AMENDMENT OF SOLICITATION/MODIFICATION OF CONTRACT				1. CONTRACT ID CODE		PAGE OF PAGES		
2. AMENDMENT/MODIFICATION NO.			3. EFFECTIVE DATE		4. REQUISITION/PURCHASE REQ. NO.		5. PROJECT NO. (If applicable)

4. Delete Sheets G-001, P-104, M-101, M-504, M-602, MI105, and MI108 and replace with the attached Sheets G-001, P-104, M-101, M-504, M-602, MI105, and MI108.

REPAIR BEQ HP510

PROJECT NO.: 18-0042

3 MECHANICAL BUILDING NORTHWEST SIDE
SCALE: 3/8" = 1'-0"

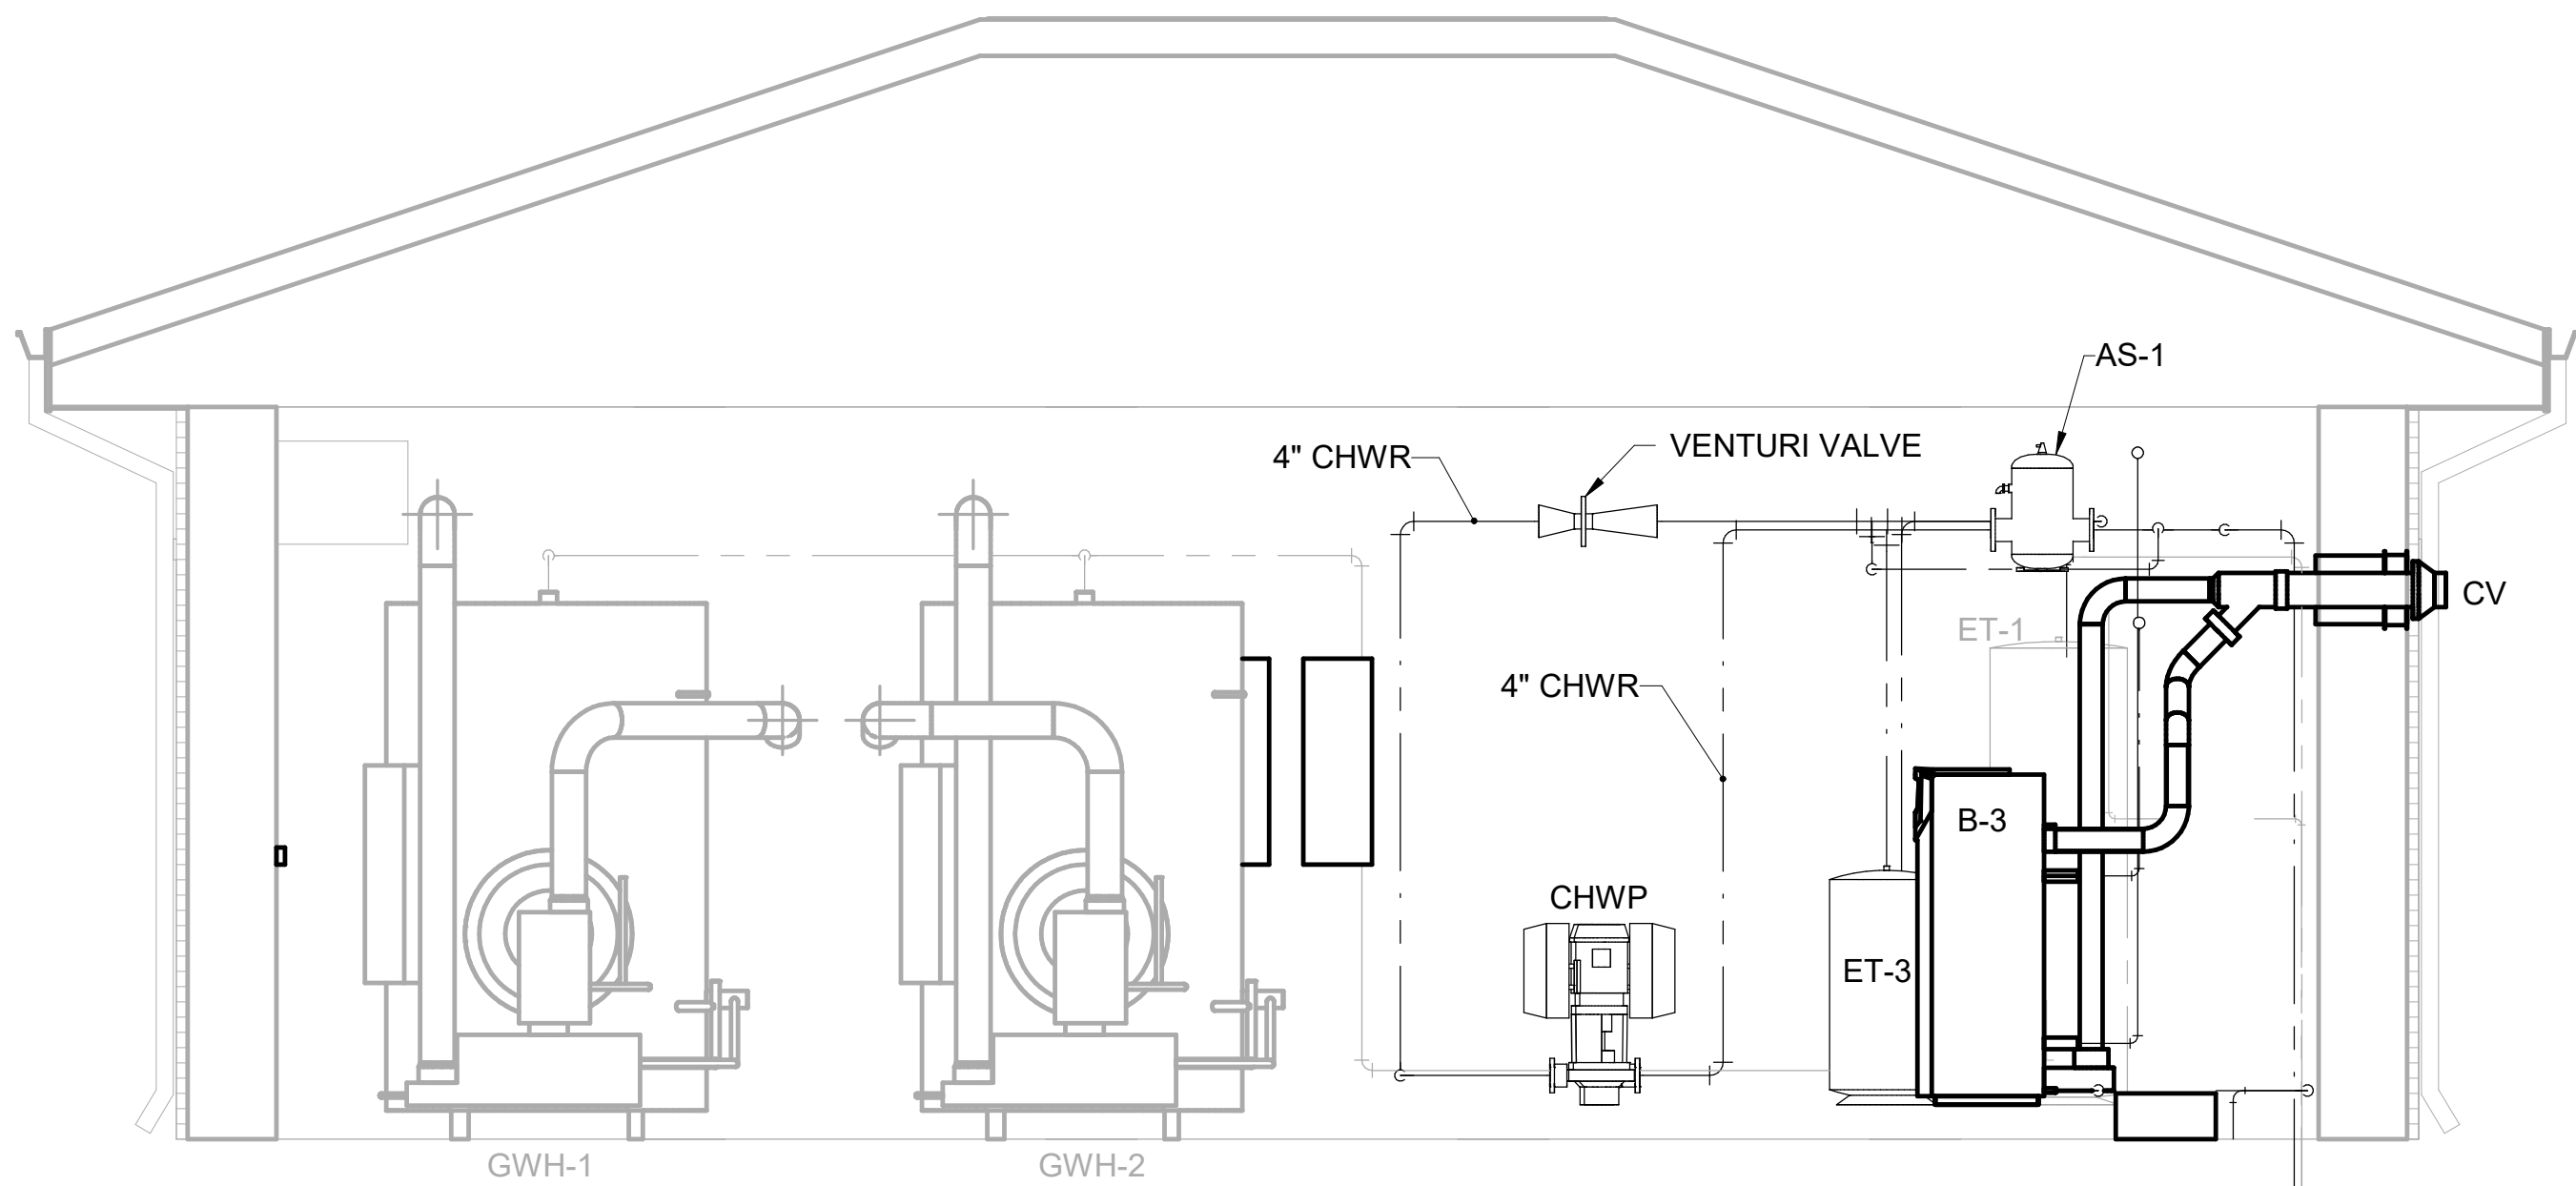
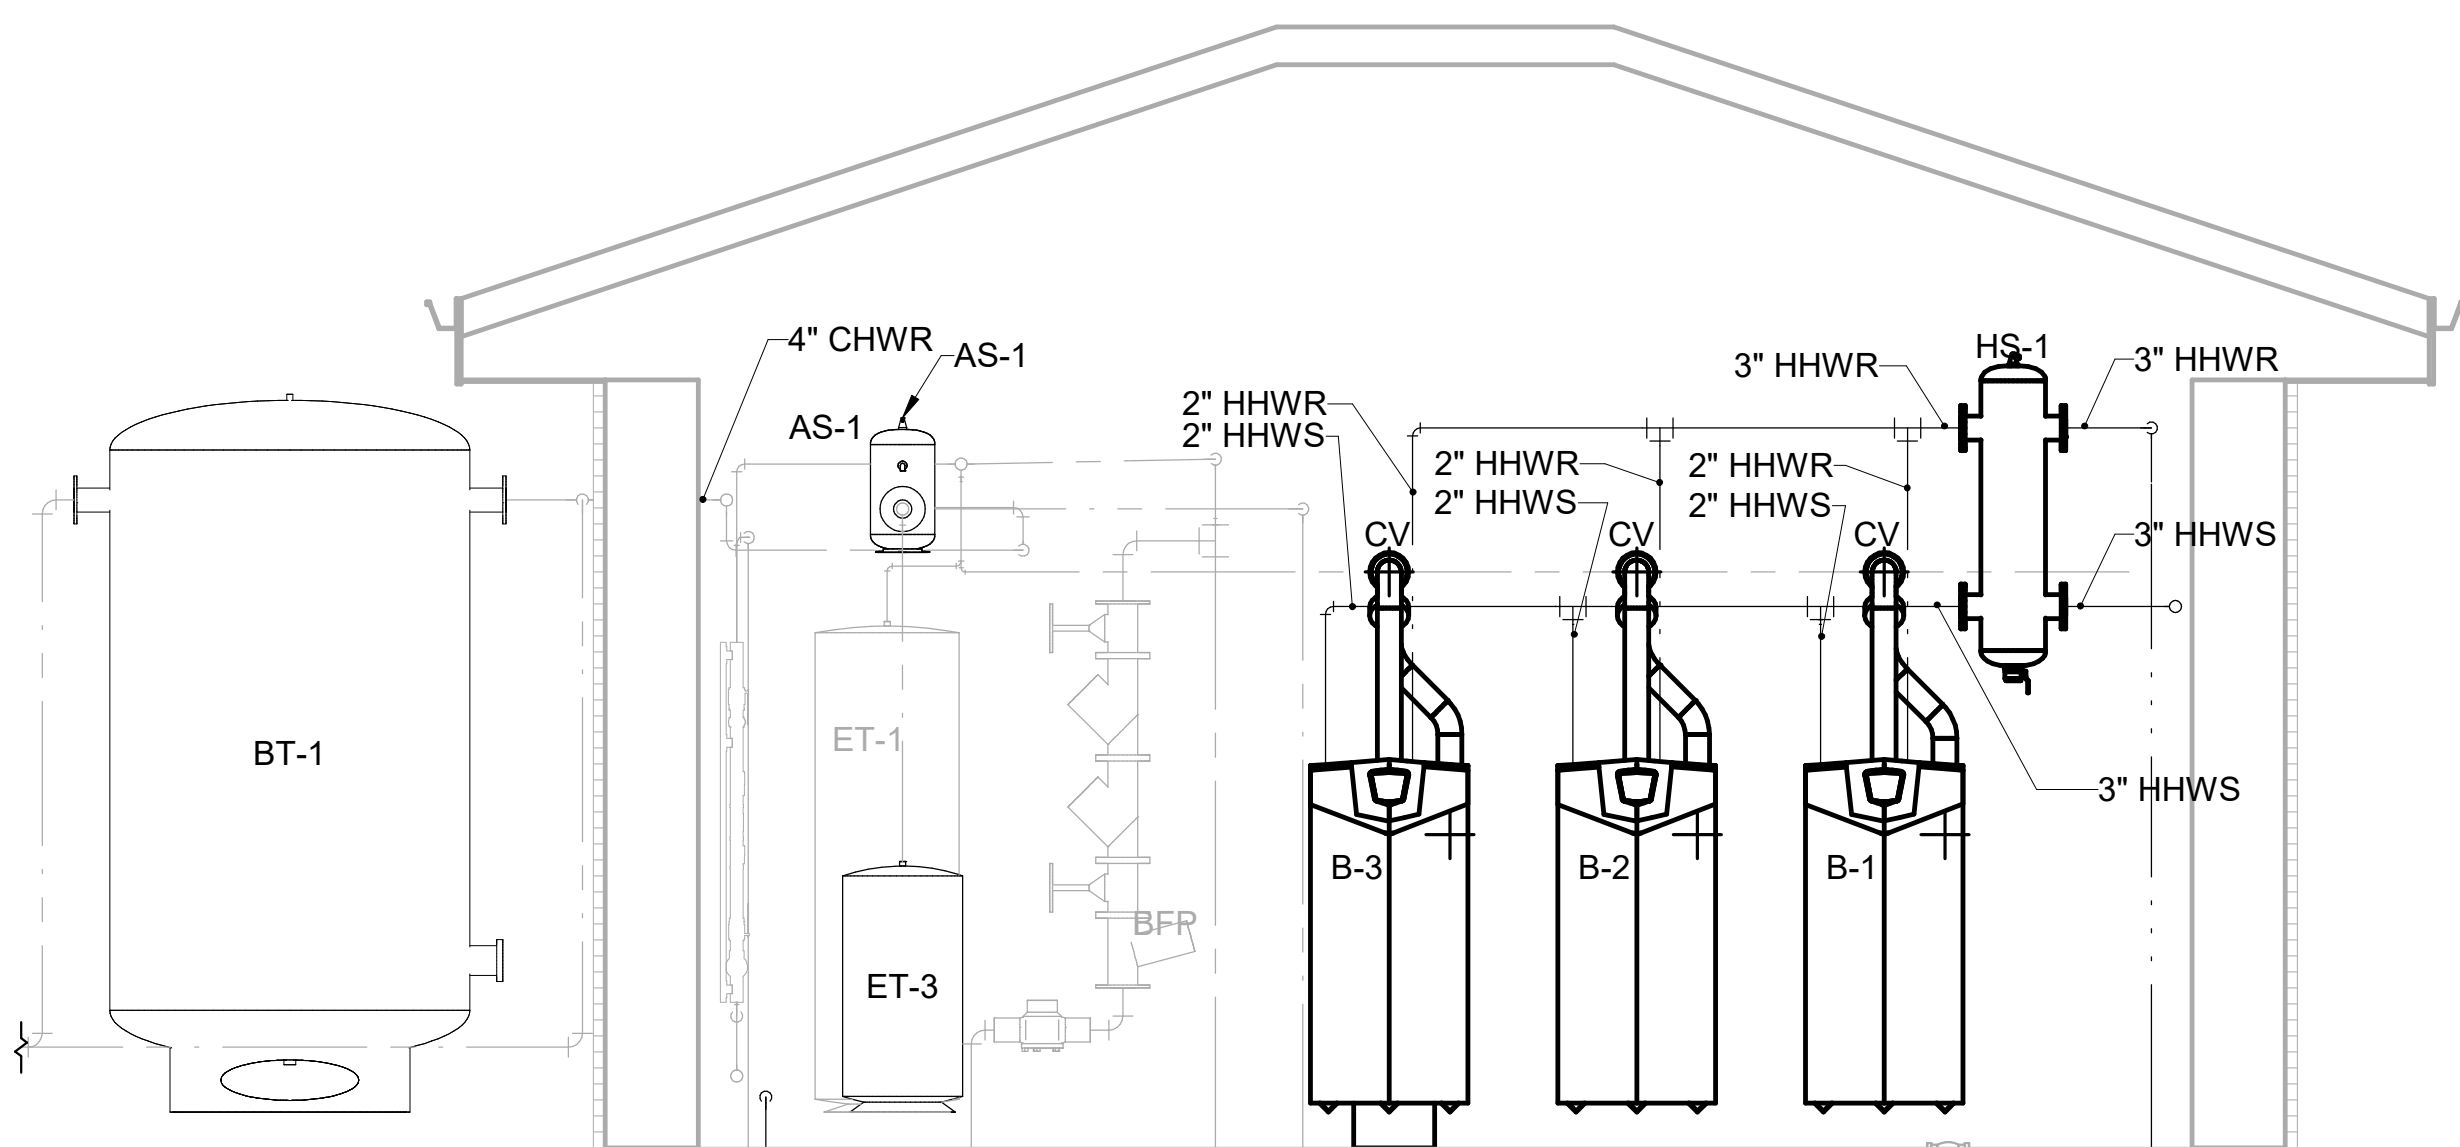
REVISIONS			
SYM.	DESCRIPTION	DATE	APPROVED
1	REMOVE ALL HEAT RECOVERY SYSTEMS	08/10/20	PCM

M-504

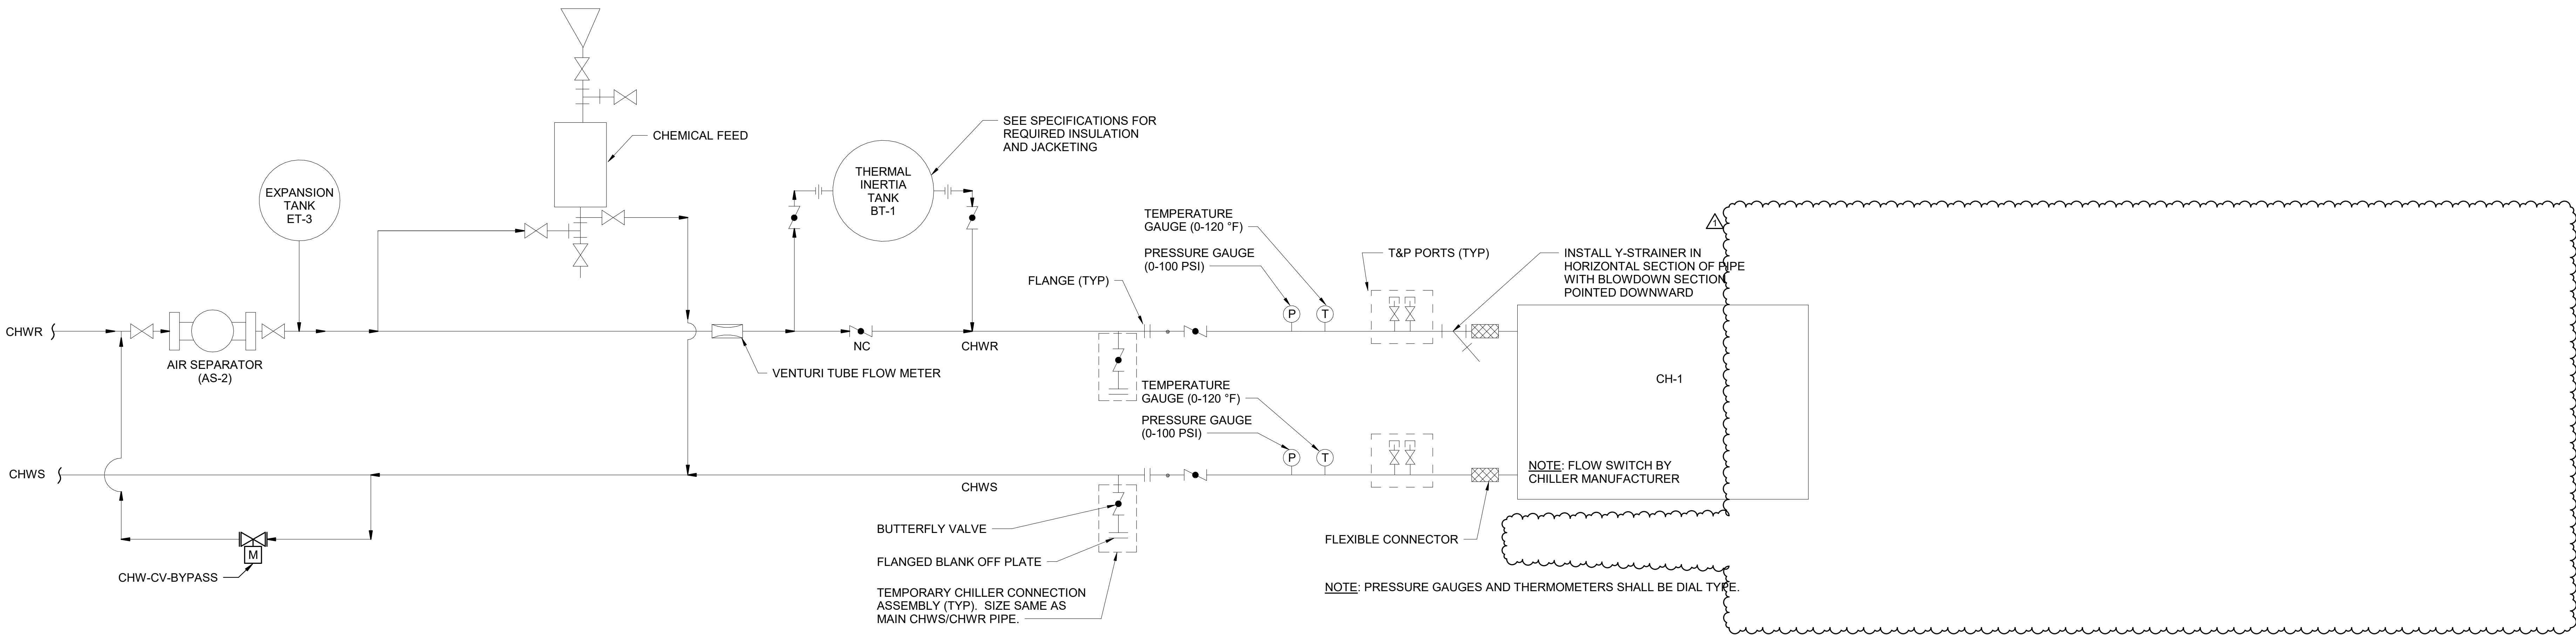
REVISIONS			
SYM.	DESCRIPTION	DATE	APPROVED
1	REMOVE ALL HEAT RECOVERY SYSTEMS	08/10/20	PCM

MI105

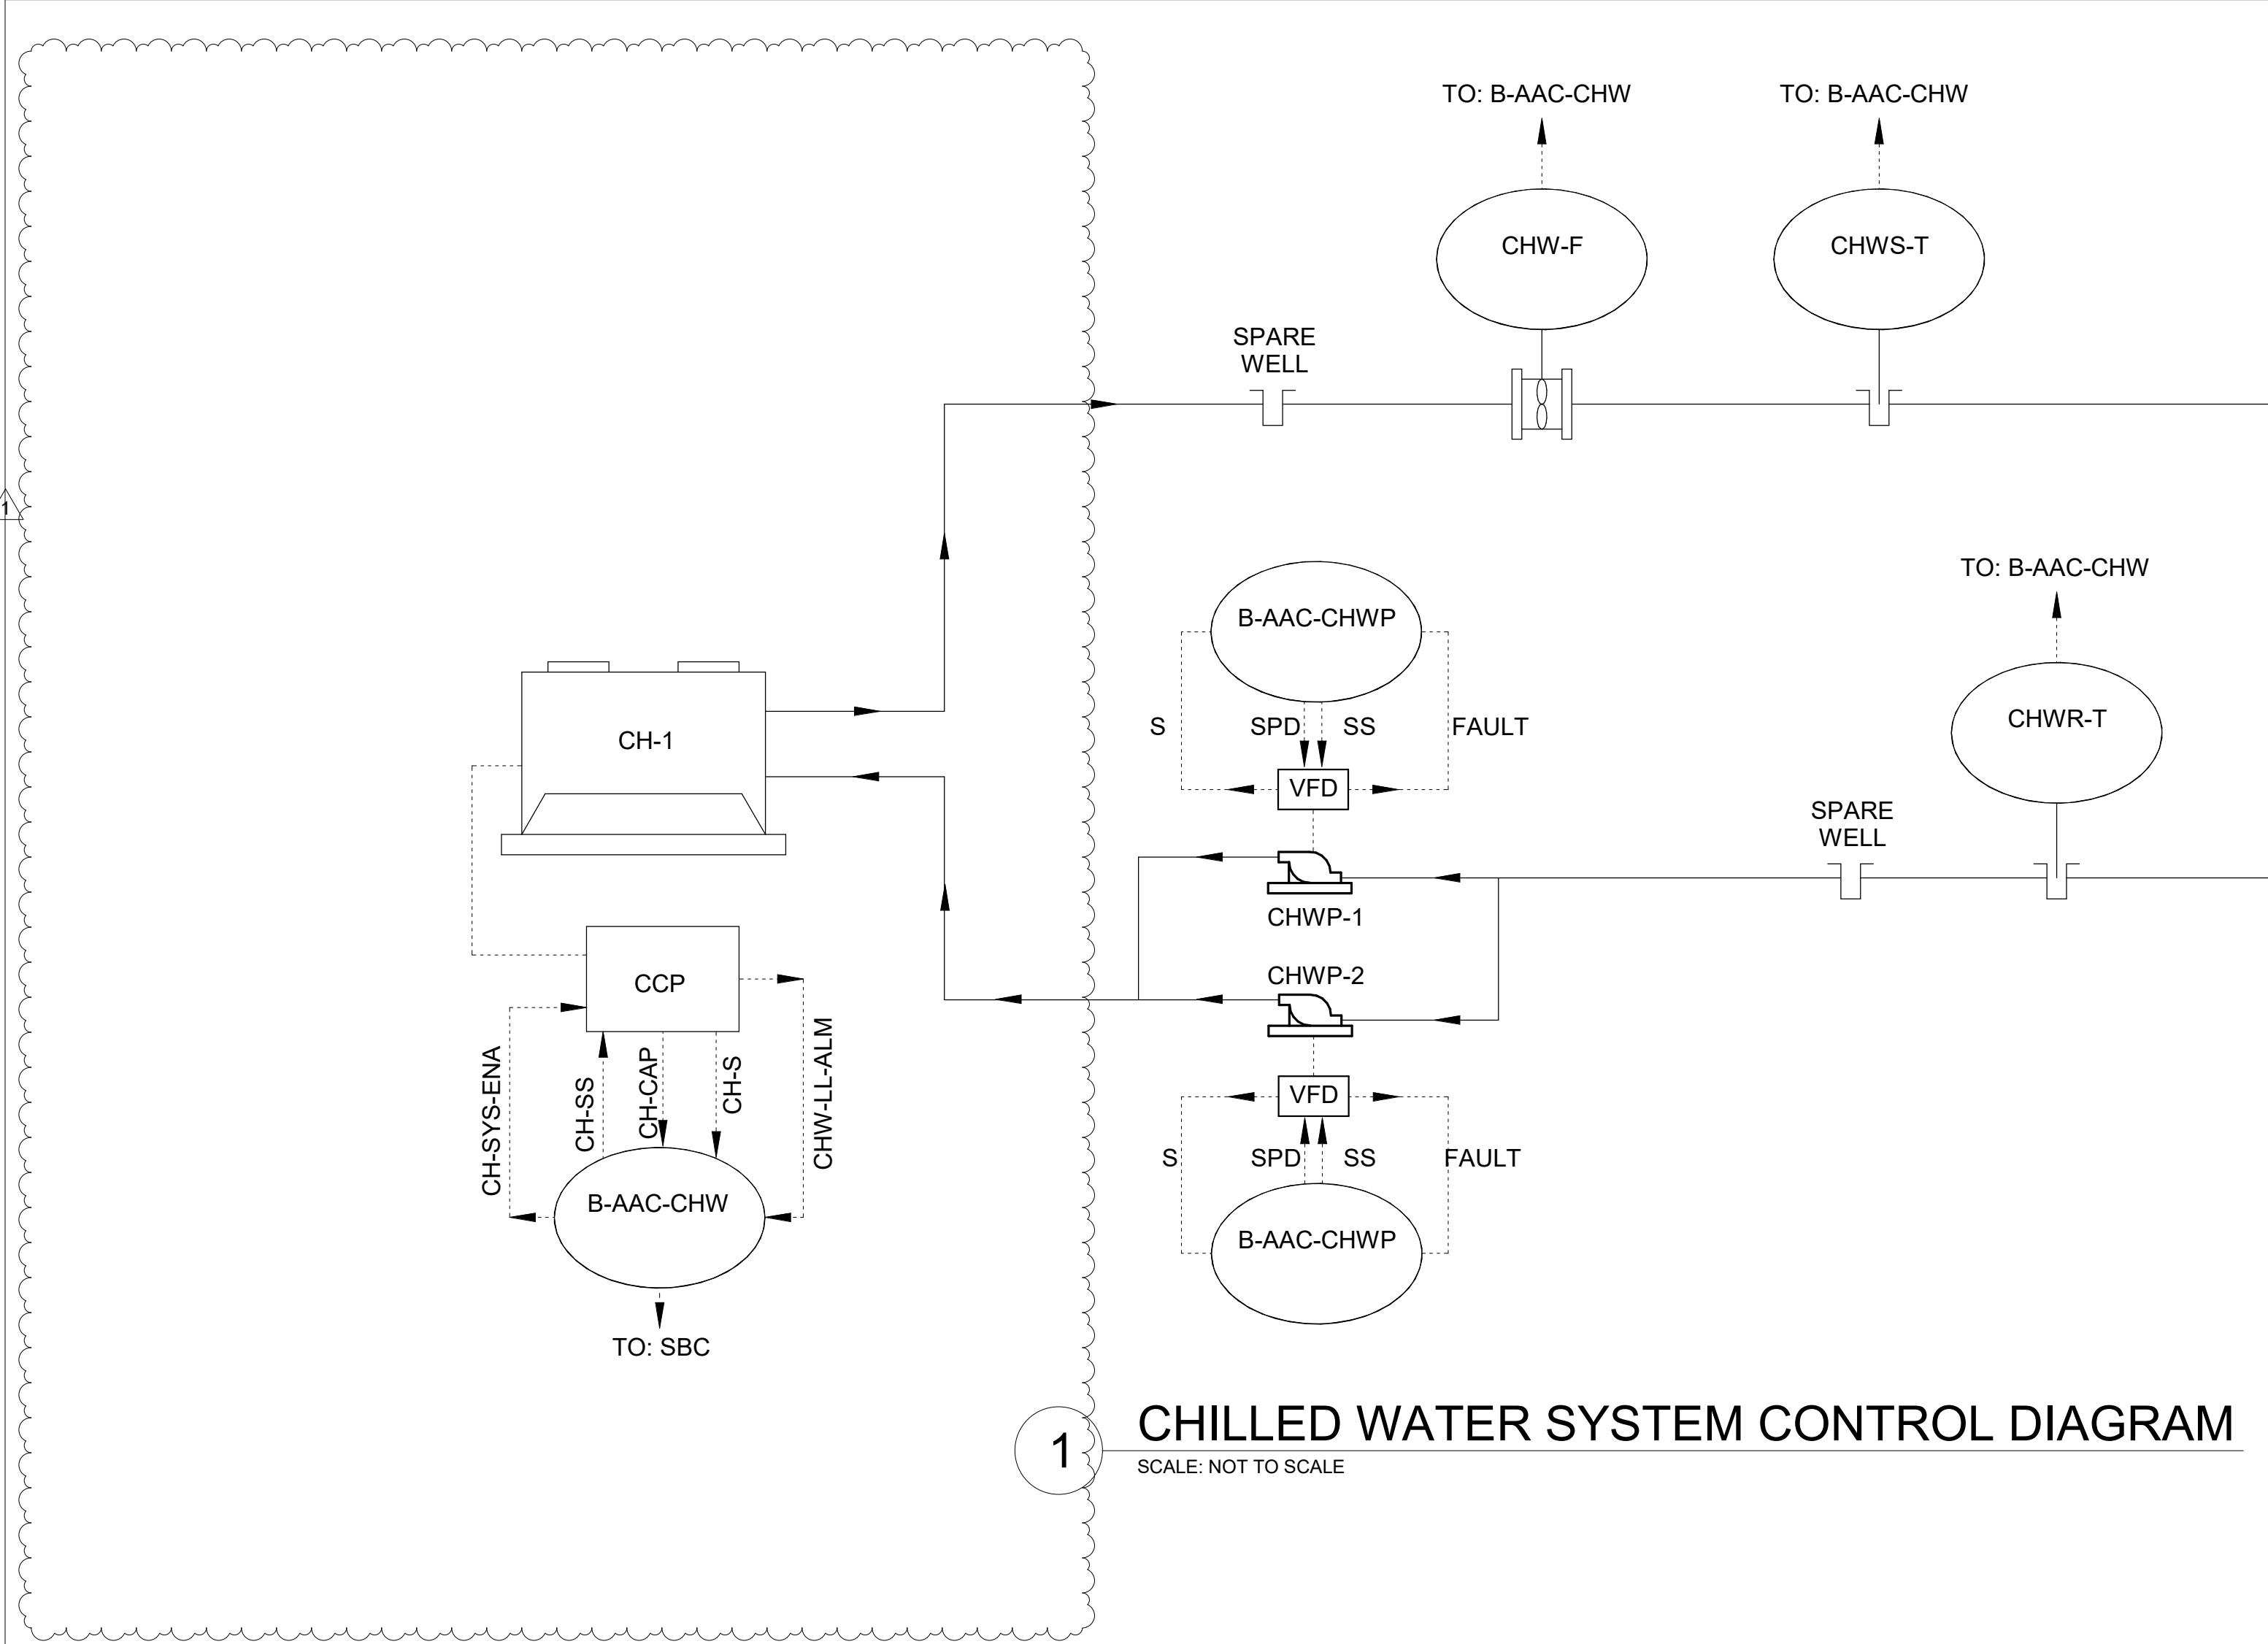
REVISIONS			
SYM.	DESCRIPTION	DATE	APPROVED
1	REMOVE ALL HEAT RECOVERY SYSTEMS	08/10/20	PCM
